No. EC120-32A014

ALERT SERVICE BULLETIN

LANDING GEAR - Landing gear Inspection for corrosion on the landing gear

Revision No.	Date of issue
Revision 0	2022-02-15
Revision 1	2022-10-17

[Figure 1](#)

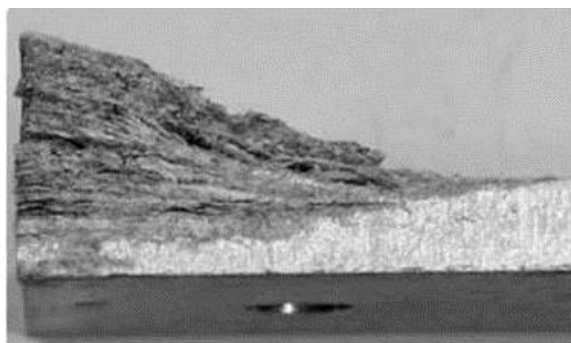
- Clean the inner side of the landing gear tubes (a), (c), (d) and (e). Refer to Work Card 20-04-01-102 and Work Card 20-04-01-402 (MTC), if necessary.
- . If you find at least one crack or leafing corrosion or exfoliant corrosion (Figures 1 and 2):
 - .. Contact Airbus Helicopters at the address that follows to get a technical solution:
 - ... Airbus World: Technical Request Management <https://airbusworld.helicopters.airbus.com>
 - ... E-mail: support.technical-optional.ah@airbus.com
 - ... Fax: + 33 (0) 4 42 85 99 66

- . If you find any corrosion within zones C or E:
 - .. Disassemble the landing gear. Refer to Task 32-12-00, 4-2 (AMM).
 - .. Remove the corrosion from all the zones. Refer to Work Card 20-90-04-101 (MTC).
 - .. Comply with paragraph [3.B.2.c](#).
- . If you find corrosion only within zones B, D, F or M:
 - .. Remove the corrosion from all the zones. Refer to Work Card 20-90-04-101 (MTC).
 - .. Comply with paragraph [3.B.2.c](#).
- . If you do not find external nor internal corrosion nor cracks:
 - .. Install the screws (j) or the blanking cap assembly (b) or (1) and the screw (k). Refer to Task 32-12-00, 4-2 (AMM) (Detail D, [Figure 3](#)).
 - .. Comply with paragraph [3.B.2.d](#).

Figure 3

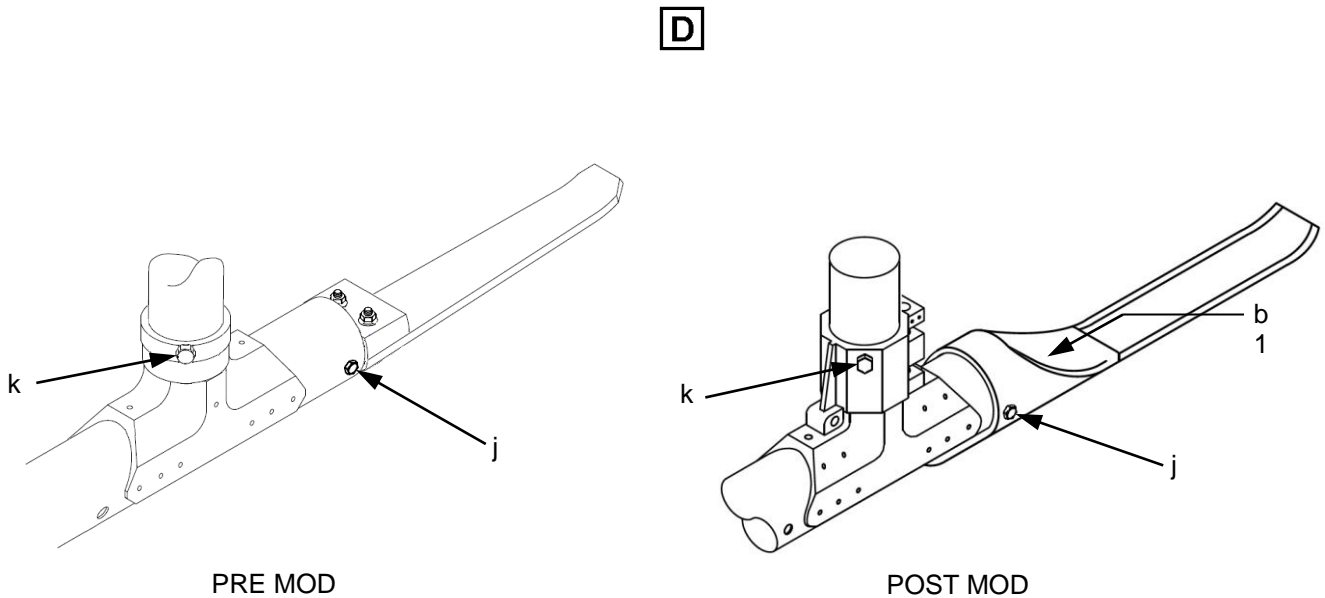
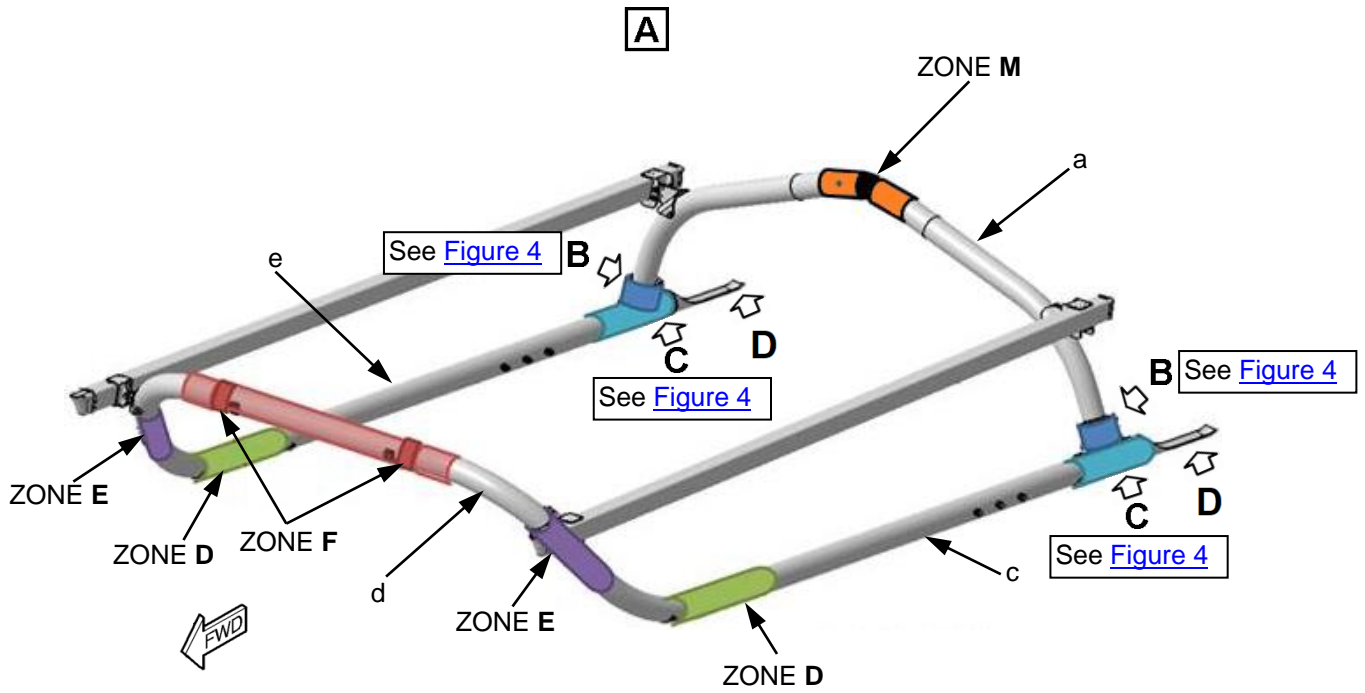
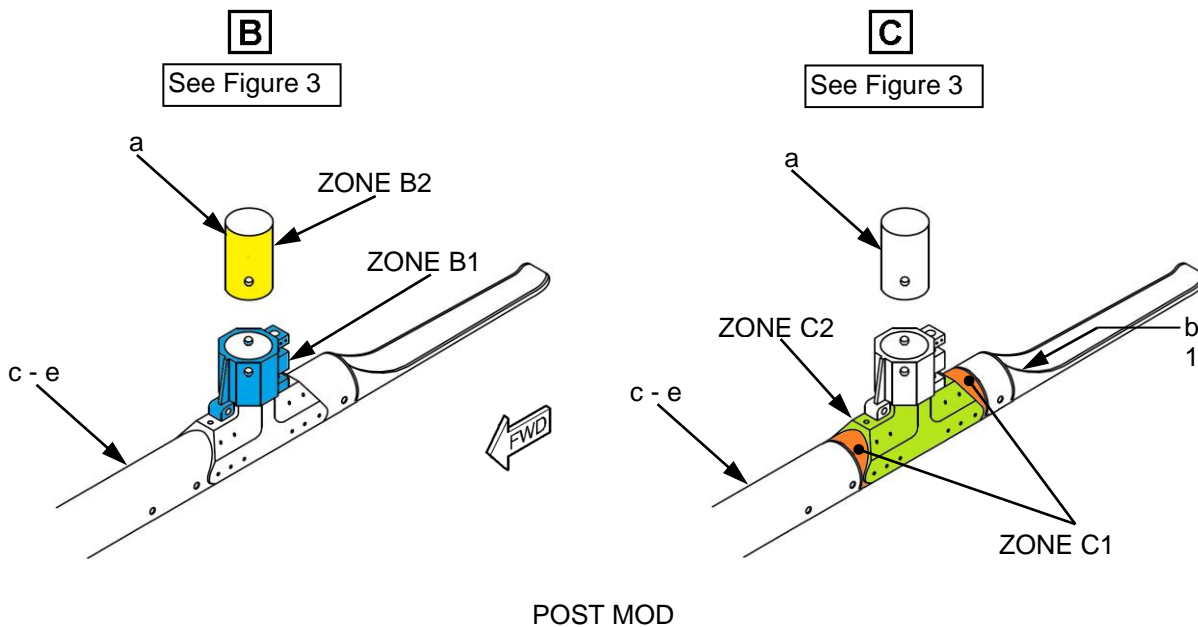
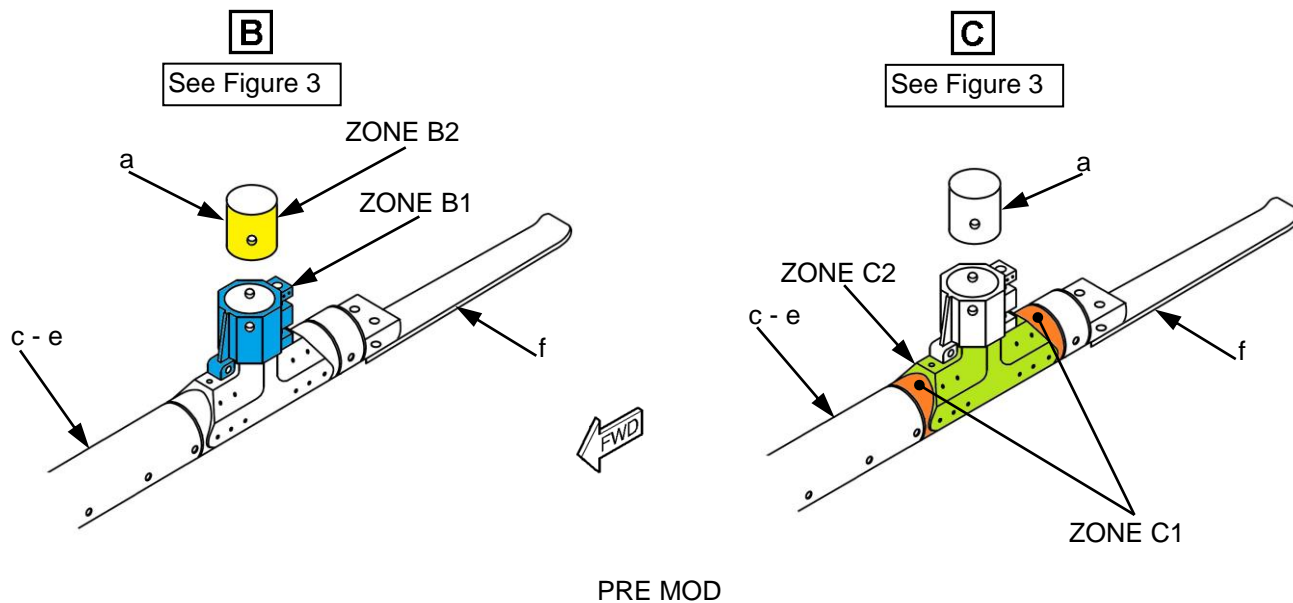
- Remove the landing gear fairing (not shown) from the rear crossbeam (a). Refer to Task 32-12-00, 4-1 (AMM).
- Clean the outer side of the landing gear tubes (a), (c), (d) and (e) (Detail A, [Figure 3](#)). Refer to Work Card 20-04-01-102 (MTC) and Work Card 20-04-01-402 (MTC).

Zones B, C, D, E, F and M are included in the cleaning and the inspection of the landing gear tubes (a), (c), (d) and (e).

- Do an external visual inspection of the landing gear tubes (a), (c), (d) and (e) to make sure that there are no cracks and no corrosion.
 - . If you find at least one crack:
 - .. Contact Airbus Helicopters at the address that follows to get a technical solution:
 - ... Airbus World: Technical Request Management <https://airbusworld.helicopters.airbus.com>
 - ... E-mail: support.technical-optional.ah@airbus.com
 - ... Fax: + 33 (0) 4 42 85 99 66

- . If you find any corrosion within zones C or E:
 - .. Disassemble the landing gear. Refer to Task 32-12-00, 4-2 (AMM).
 - .. Remove the corrosion from all the zones. Refer to Work Card 20-90-04-101 (MTC).
- . If you find corrosion only within zones B, D, F or M:
 - .. Remove the corrosion from all the zones. Refer to Work Card 20-90-04-101 (MTC).
- . Then, in all cases, comply with paragraph 3.B.2.b.

- With the borescope (zz), examine the inner side of the landing gear tubes (a), (c), (d) and (e) for corrosion and cracks. Refer to Detail A, [Figure 3](#), and the criteria of [Table 3](#).

To do the borescope inspection of the landing gear tubes (a), (c), (d) and (e), you can remove the screws (j) or the blanking cap assembly (b) (Detail D, [Figure 3](#)). Refer to the principle of Task 32-12-00, 4-2 (AMM).

To do the borescope inspection of the landing gear tube (a), you can remove the screws (k) (Detail D, [Figure 3](#)). Refer to the principle of Task 32-12-00, 4-2 (AMM), if necessary.

Table 3		
Zones	Location	Permitted criteria
M	Below the two half-bearings of the rear crossbeam (a).	Make sure that there is a minimum thickness of 7 mm (.275 in.).
	Over 100 mm (3.937 in.) inboard and 100 mm (3.937 in.) outboard of the clamp	
B1	On the LH/RH fitting, in the rear crossbeam (a) fitting zone, (Detail B, Figure 4).	Make sure that there is a minimum thickness of 3.4 mm (.133 in.).
B2	On the LH/RH rear crossbeam (a), in the fitting zone, (Detail B, Figure 4).	Make sure that there is a minimum thickness of 4 mm (.157 in.).
C1	On the LH/RH skid assemblies (c) and (e), (Detail C, Figure 4).	Make sure that there is a minimum thickness of 2.3 mm (.090 in.).
C2	On the fitting, in the junction zone of the LH/RH skid assemblies (c) and (e), (Detail C, Figure 4).	Make sure that there is a minimum thickness of 2.3 mm (.090 in.).
D	Zone of the LH/RH front footstep.	Make sure that there is a minimum thickness of 2.4 mm (.094 in.).

E	On the front crossbeam (d).	Make sure that there is a minimum thickness of 2.3 mm (.090 in.).
	On the LH/RH skid assembly (c).	Make sure that there is a minimum thickness of 1.9 mm (.075 in.).
F	Below the half-bearings of the front crossbeam (d).	Make sure that there is a minimum thickness of 2.9 mm (.114 in.).
	From 100 mm (3.937 in.) outboard of the LH clamp to 100 mm (3.937 in.) outboard of the RH clamp.

- Below the collar in zones M and F ([Figure 3](#)) and in the reworked zones, apply:
 - . Chemical conversion coating (Alodine 1200) (2). Refer to Work Card 20-90-05-401 (MTC).
